STAFF REPORT: 11/12/2025 REGULAR MEETING

APPLICATION NUMBER: HDC2025-00596

ADDRESS: 4324 (4314-4316) W. VERNOR

SCOPE: REMOVE BRICK VENEER AT FAÇADE, INSTALL NEW BRICK CLADDING AND STOREFRONT

Staff photos, 10/24/2025. No elements within the yellow box are historic.

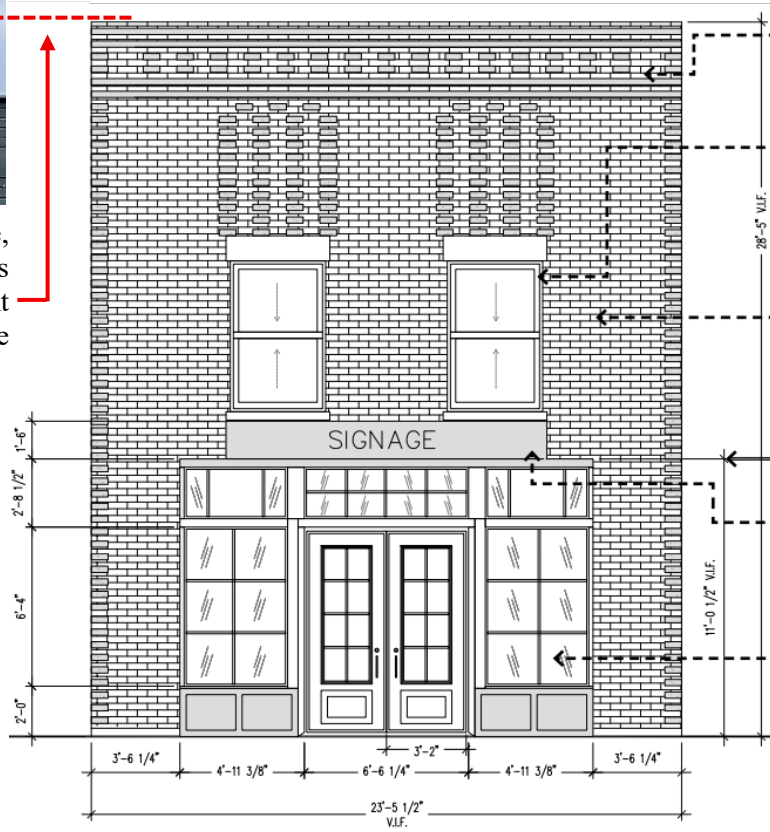
- The existing storefront, characterized by its mostly brick infill and minimal detailing, appears to reflect a more modern, mid-century design. This is evident in the use of thinner, elongated bricks, which contrast with the more ornamental features, such as decorative wood panels, typically found in earlier historic storefronts.

*Brampton Brick
Old Chicago*

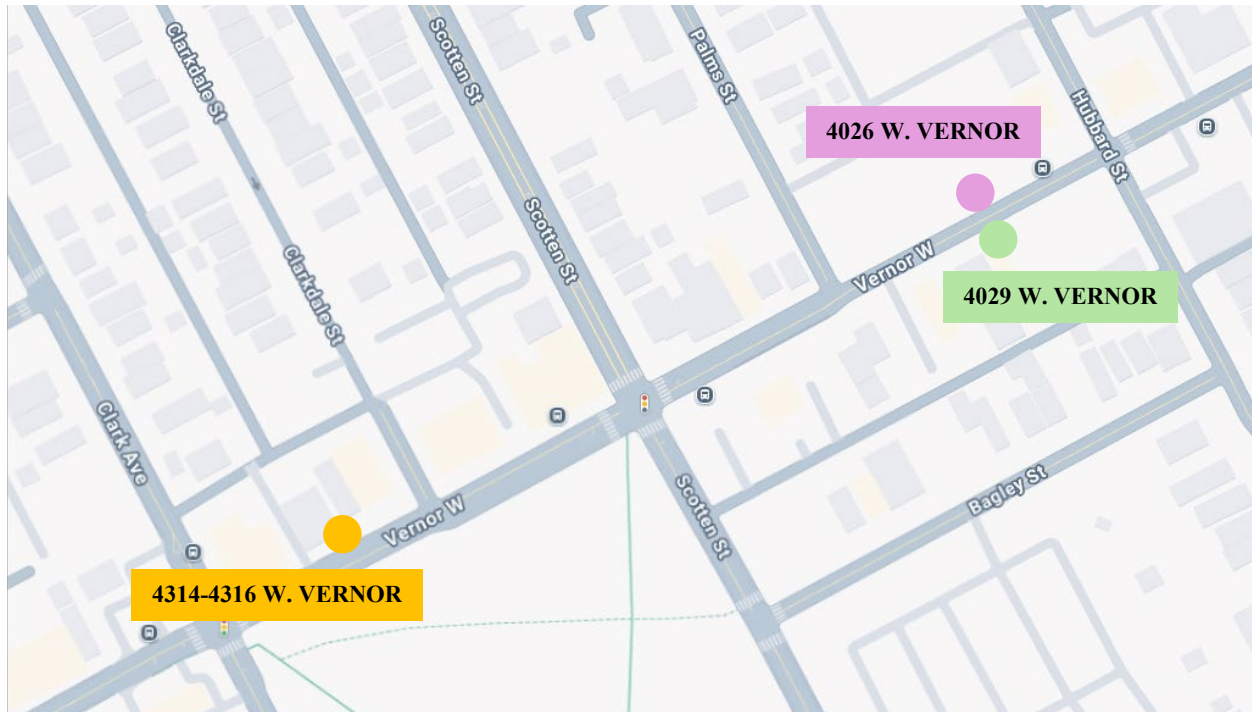
With the new façade, the applicant proposes to increase the height to align with the building to the West.

- It is staff's opinion that the applicant's proposal to remove the existing historic brick veneer at the façade is inappropriate, as the existing brick veneer is a distinctive, character-defining feature and has not been demonstrated to be beyond repair. Furthermore, the proposed new brick cladding, with its cornice and brick patterning, conveys a misleading representation of historic brick architectural details and creates a false sense of historical development. These elements are incompatible with the building's authentic and simplistic historic character.

Recommendation 1 of 2 – Denial – Remove brick veneer at façade, install new brick cladding
